Appeal of Planning Commission Resolution No. 26-05 Regarding Coastal Development Permit No. 19-012 (25200 Pacific Coast Highway, APNs 4459-013-021 and 4459-014-018; Owner, PAR PCH, LLC; Appellant, Jun Hall for Concerned Citizens of Malibu Road, Inc.)

Malibu City Council
Special Meeting Agenda

Wednesday, August 19, 2026

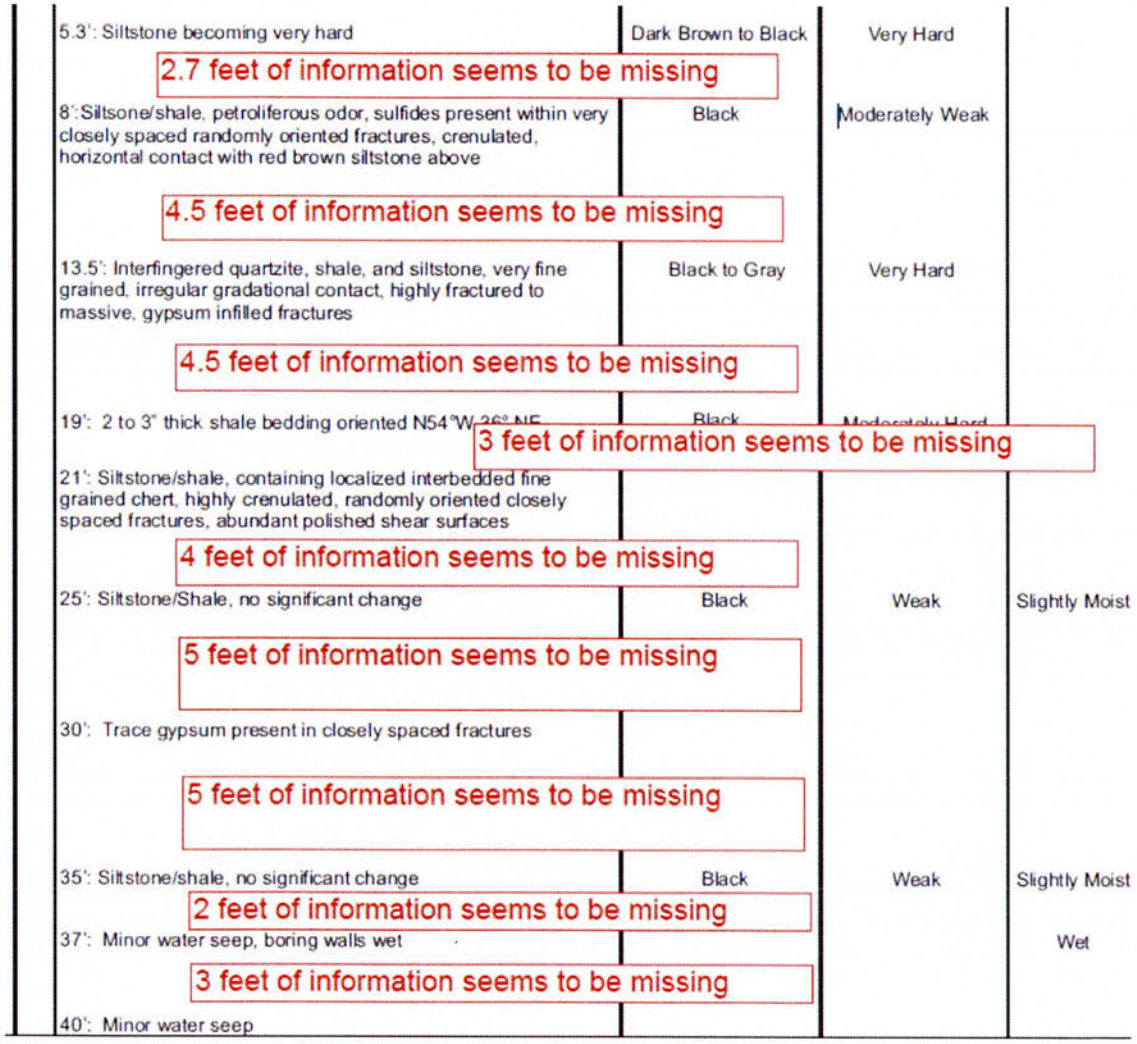
The concerns regarding the characterization of subsurface materials in Feffer's borings remain unaddressed. Specifically:

- Older consultants' reports documented crushed, disturbed, or sheared materials consistent with landslide deposits, while Feffer logs classify similar intervals as "bedrock" without explanation.
- Gaps in log descriptions at depth and a lack of detailed material characterization were not addressed and did not meet the industry standard of care.
- No explanation was provided for discrepancies between historic logs and Feffer's own interpretation.

As stated in the prior technical letter, continuous subsurface investigation is critical to defining landslide geometry and failure mechanisms. Continuous boring logs are essential. Industry standards require logging every vertical inch of the borehole and documenting lithology changes, shear zones, bedding attitudes, fractures, clay seams, and disturbed materials. Terms such as *smashed*, *jumbled*, *pulverized*, *reworked*, *slickensides*, and *polished shear surfaces* are commonly used to describe materials disturbed by landslide movement.

***Figures 7 & 8:** Appellant's photos which are clearly taken from the applicant's property and not from PCH, as is claimed in figure 8.*

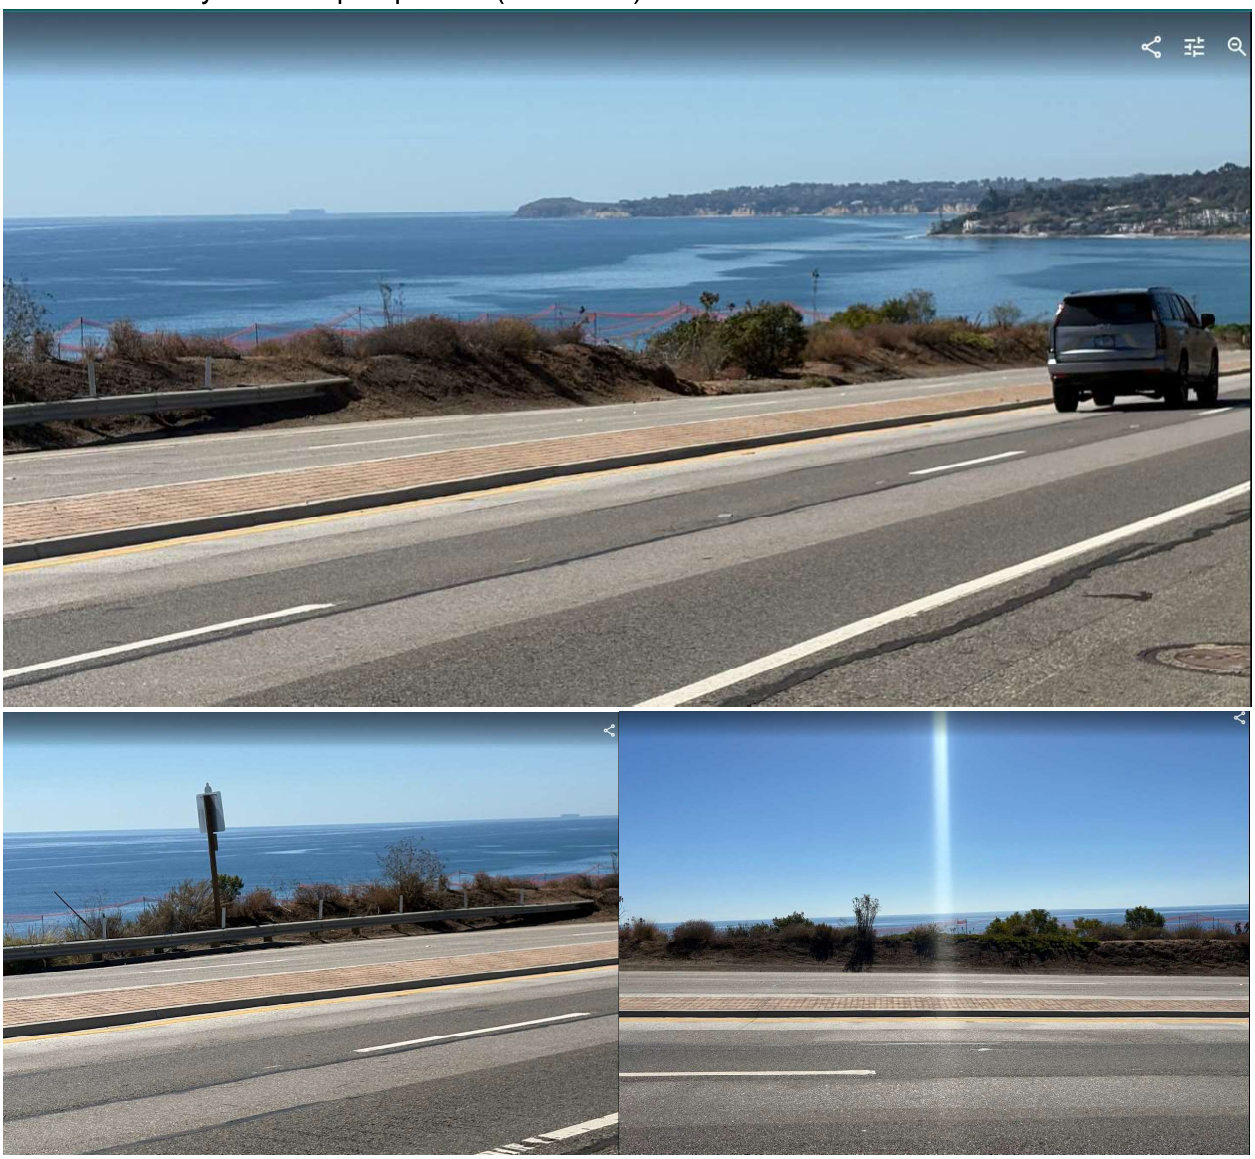
Again, the applicant's photos accurately show the relevant elevations of the story poles vis a vis the PCH roadway and berm. The applicant's photos below and the project rendering provide a clear picture of the minimal view blockage of the house design. Planning staff viewed the poles from PCH, photo documented the same and reviewed the applicant's renderings and have found them reliable and accurate as verified by staff's visits to the property. The appellants assertion

that the house blocks all views of Catalina and Palos Verdes is a contrivance supported by photos taken +-11' below PCH. The photos immediately below, taken by the applicant's representatives, show an entirely different perspective (from PCH).
